# PONTIAC

## Service Craftsman News

No. 10 S-277

# ADDITIONAL 1956 INFORMATION

Fig. 1 Spring Clip Installed

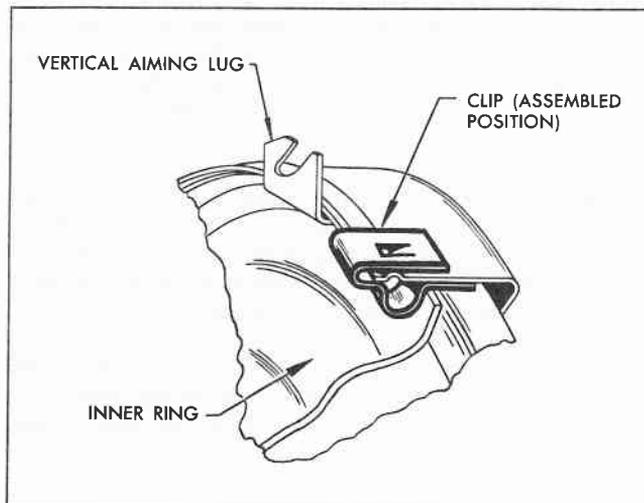
When installing Guide T-3 headlamps on 1955 models equipped with Guide headlamps having retaining rings with attached aiming lugs, install a spring clip on each unit as shown in Fig. 1 to ensure rigidity of the assembly. Leave clip in place after aiming. Clips are available through G.M.P.D. Warehouses under part number 5947710 (package of 10).

Fig. 4 Safari Lift Gate

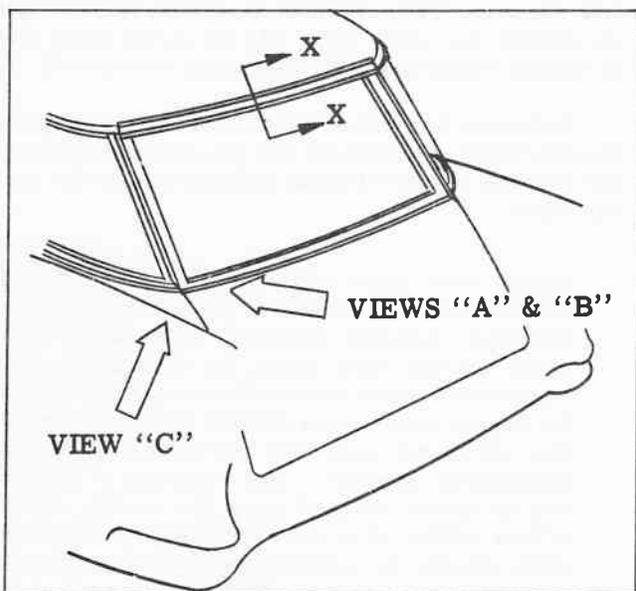
Since the May "News" was issued, several changes in the lift gate sealing have been made in production. The following information has been prepared to inform the field of the new parts and of their use in the elimination of possible waterleaks on bodies which do not have a lift gate weatherstrip (body side) retained by a metal retainer.

#### LIFT GATE (FIG. 4)

1. Remove lift gate from body opening (detach lid from hinge straps).
2. Remove all lift gate weatherstrips (lift gate side and body side) and clean off cementing surfaces.
3. If the rear quarter window lower rear reveal molding has a tab as shown in View "A", Fig. 6, cut tab from molding. Reinstall screw in original hole in lower end of rear quarter window rear reveal molding. If no screw is present, drill hole, seal and install screw (part #442610) to

Fig. 5 View Through X-X Fig. 4

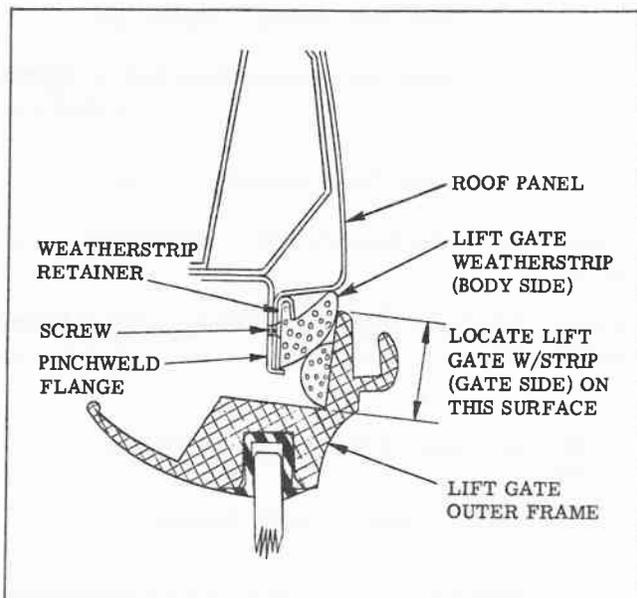
5. Correct any irregularities in the roof panel-to-back body opening outer rail pinchweld flange and then locate upper weatherstrip retainer along pinchweld flange. See Fig. 5.

7. Drill a 1/8 inch diameter hole through retainer and pinchweld flange at each hole location. See Fig. 5, for location of retainer. Remove retainer and paint retainer with primer.

10. Cement new lift gate weatherstrip (body side) in position and crimp upper flange of retainer over weatherstrip as shown in Fig. 5.

12. Touch up exposed section of retainer with body color paint.
13. Lubricate contact area of weatherstrip with film of silicone rubber lubricant.
14. Install new lift gate upper weatherstrip (gate side) to obtain the required weatherstrip contact as shown in Fig. 5.
15. Install new lift gate lower corner weatherstrips flush with edge of lift gate as shown in Fig. 7.
16. Install and align lift gate to obtain proper spacing and weatherstrip contact at all points. If required contact between lift gate weatherstrip (body side) and lift gate weatherstrip (gate side) is not obtained with lift gate properly aligned, relocate the lift gate weatherstrip (gate side) to obtain required weatherstrip contact. See Fig. 5.

Fig. 6 Views "A" and "B" Fig. 4

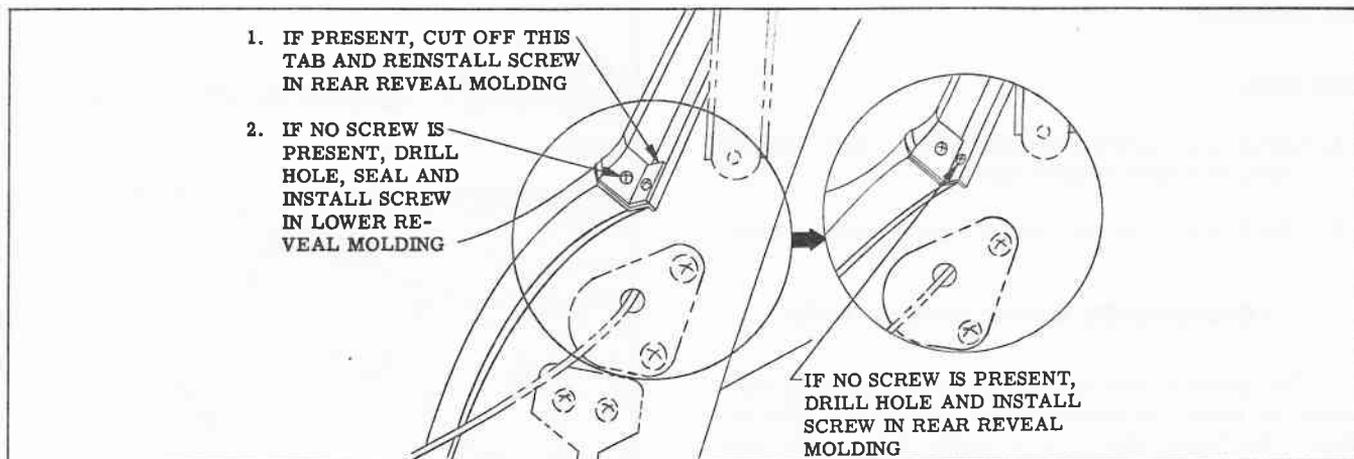
4. If the rear quarter window rear reveal molding does not have a tab or screw at the lower end as shown in View "B", Fig. 6 install screw to obtain a better fit.
